Service Letter: No. 342

Subject: Change of Heater Bleed Air Shutoff Valve Orientation.

Applicability: Bell Helicopter Model 427 equipped with Air Comm Corporation Bleed Air Heater System.

Reference: F.A.A. / S.T.C. SR00419DE
Drawing # 427H-510 Rev. F

Figure 1-2, Revised S-9730EC-1 Shutoff Valve Mounting Configuration

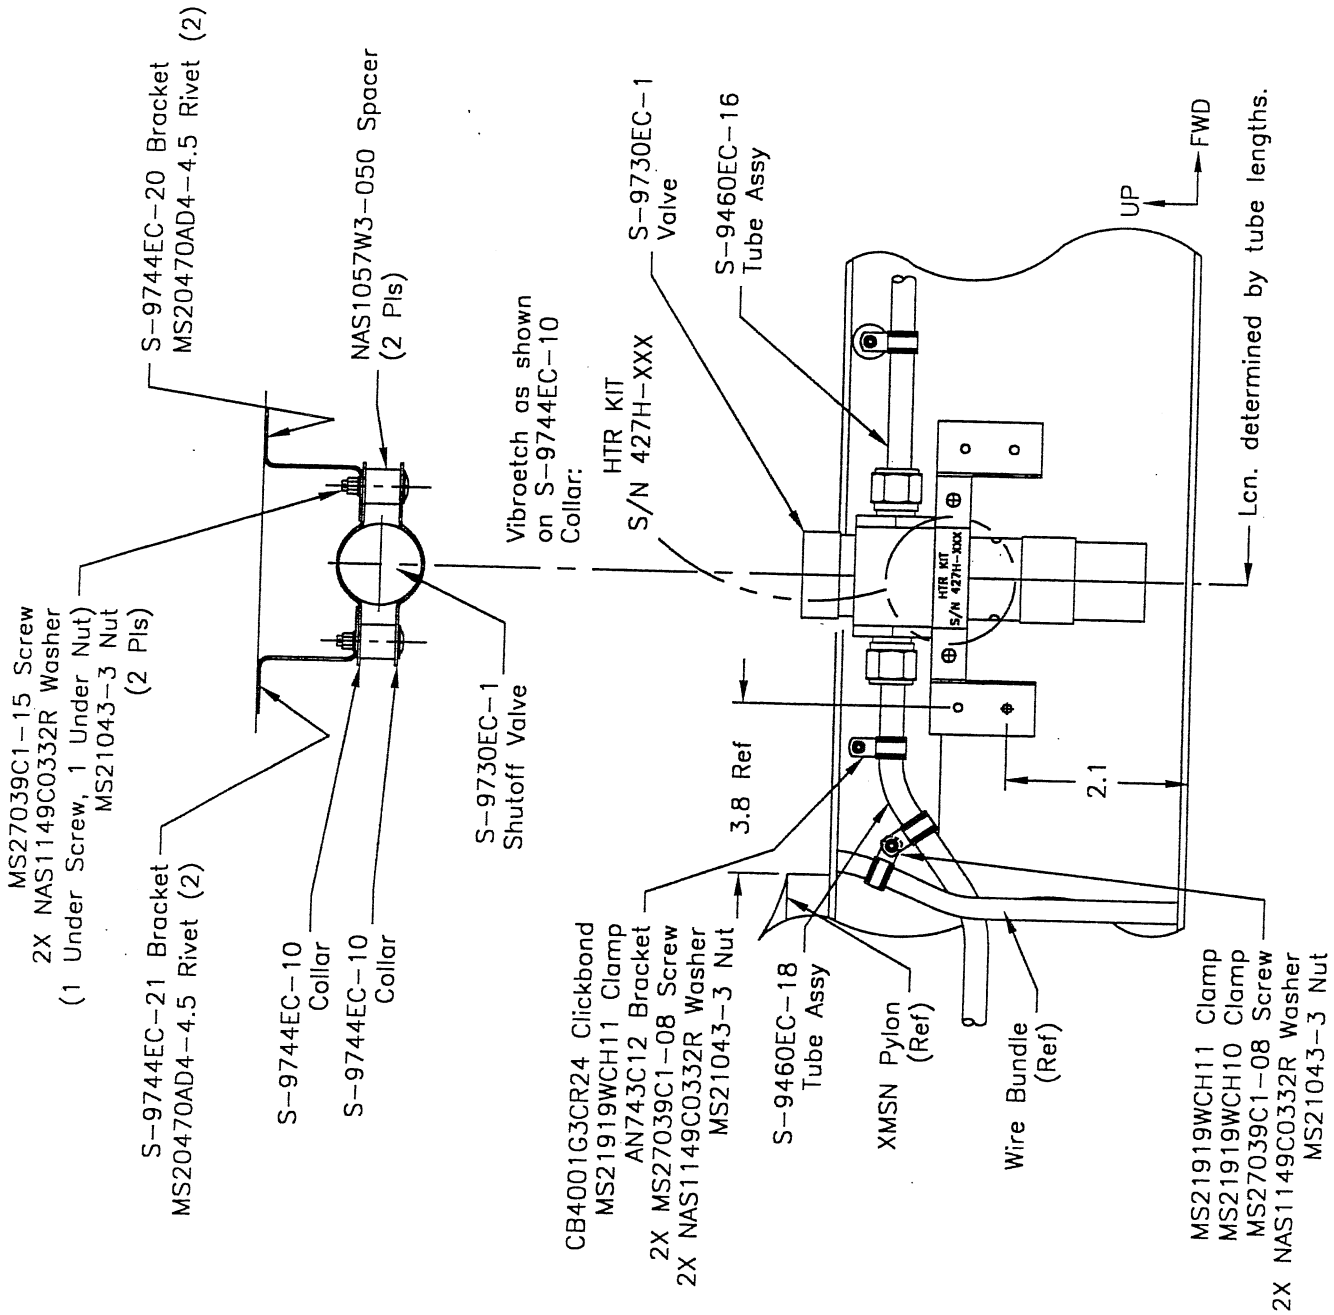
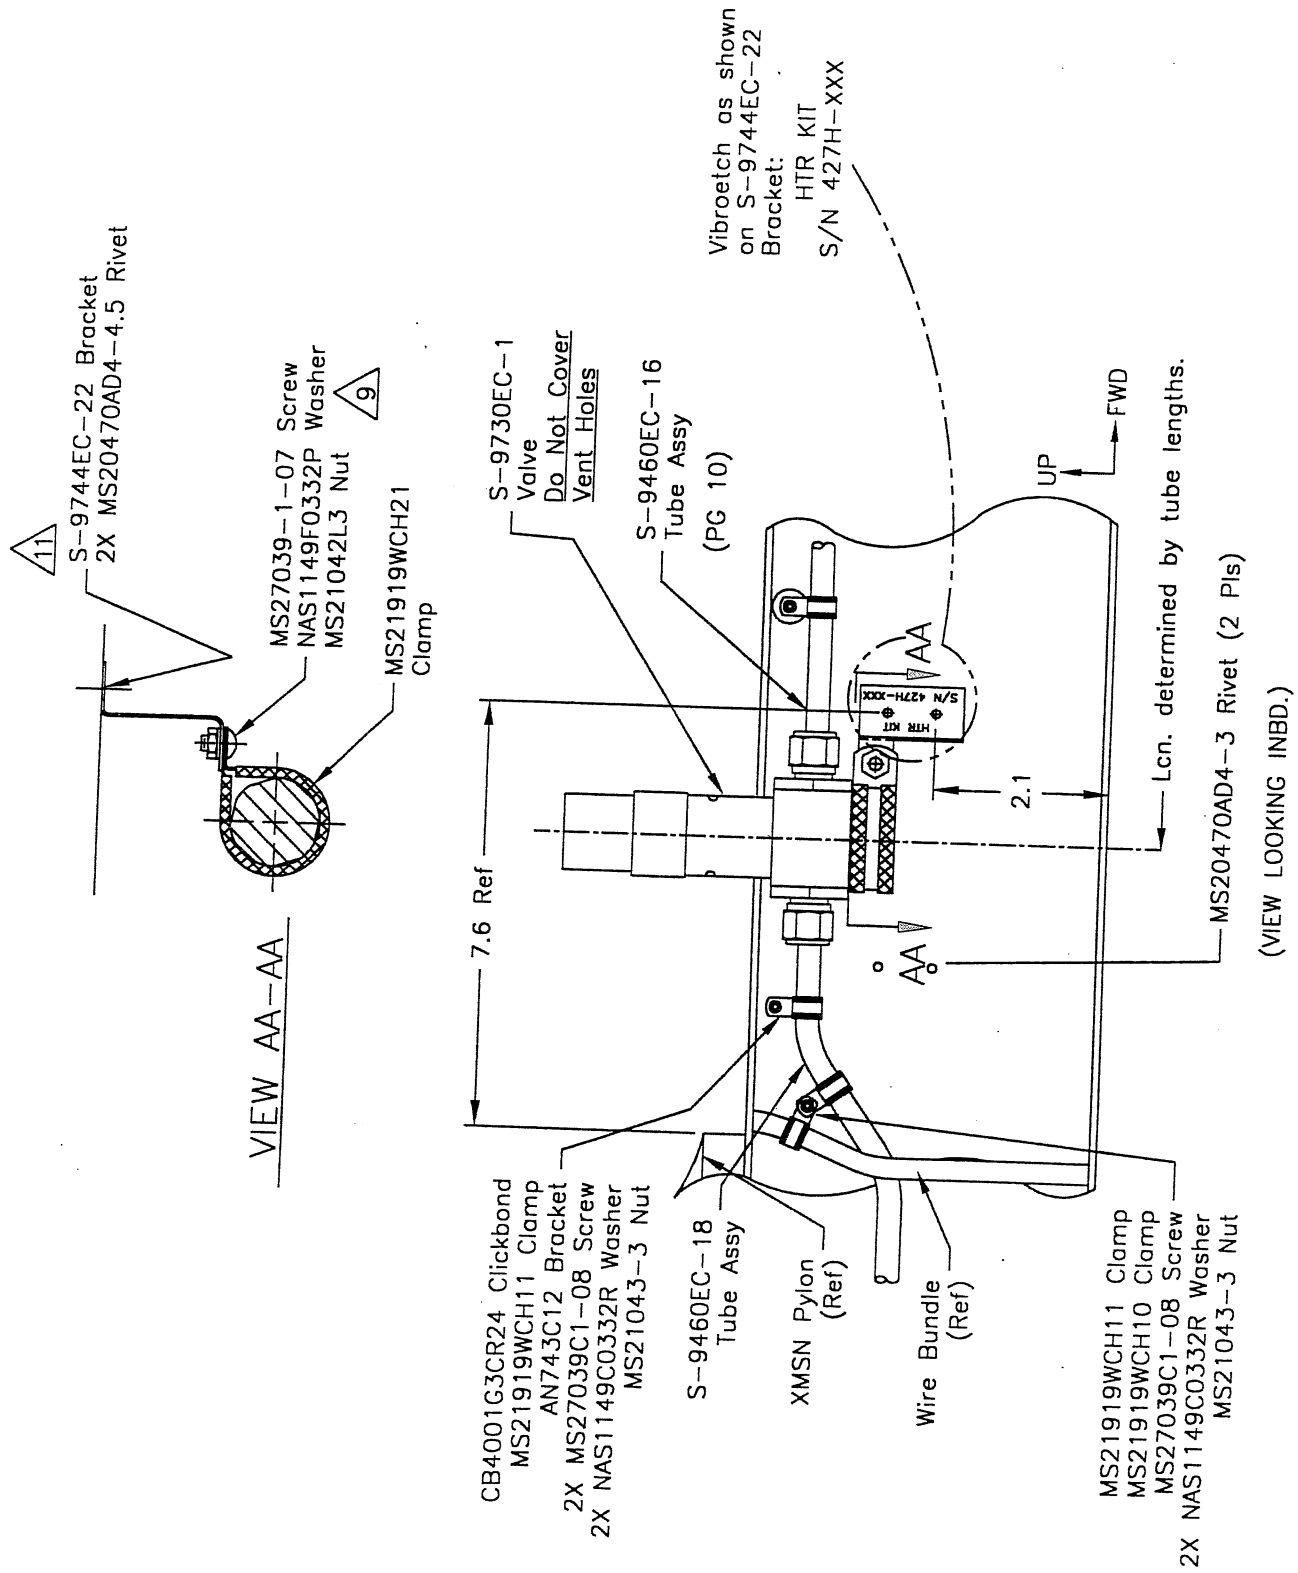
We have found that by reversing the existing orientation of the Heater Shutoff Valve will help increase the service life expectancy of this part.

1. Remove and discard the two (2) MS27039C-15 Screws, NAS1149CO332R Washers, MS21043-3 Nuts, and NAS1057W3-050 Spacers from the S-9744EC-10 Collar that supports the S-9730EC-1 Shutoff Valve. Remove and discard the inboard and outboard S-9744EC-10 Collar at this time as well.
2. Disconnect the S-9760EC-16 & -18 Tube assemblies from the fittings on the S-9730EC-1 Shutoff Valve Assembly, and remove the Shutoff Valve from between the tubes.

3. Remove the MS20470AD4-4.5 Rivets (2 Pls) from the S-9744EC-20 and S-9744EC-21 Brackets, and discard Brackets.

1. Install MS20470AD4-3 Rivets (2 Pls) in the holes left blank from the removal of the S-9744EC-21 Bracket. (See note 11)
2. Install the S-9744EC-22 Bracket using MS20470AD4-4.5 Rivets (2 Pls) using the existing holes from the removal of the S-9744EC-20 Bracket. (See note 11)
3. Reinstall the S-9730EC-1 Shutoff Valve with the valve body orientated as shown in Figure 1-2.
4. Install the MS21919WCH21 Clamp on the end cap of the S-9730EC-1 Shutoff Valve as shown in Figure 1-2.

5. Install attaching hardware MS27039-1-07 Screw, NAS1149F0332P Washer, and MS21042L3 Nut through the MS21919WCH21 Clamp and S-9744EC-22 Bracket.
(See note 9)
6. Reinstall the B-nuts on the fittings of the S-9730EC-1 Shutoff Valve and torque per MS21344.
7. Perform Maintenance Operational Check (MOC) on completion of this Service Letter as follows:
 - a. Disconnect the S-9460EC-1 Tube from the Engine Bleed system (See figure 1-3).
 - b. Close the heater and defroster control valves located in the cockpit.
 - c. Connect shop air (compressed air) to the S-9460EC-1 Tube.
 - d. Apply 80 to 100 psig air pressure to the system.
 - e. Operate the HTR-OFF-OVRD switch to HTR (note: Bleed line must be pressurized to open the Shutoff Valve).
 - f. Check fittings for audible leaks (Do Not use soap bubbles).
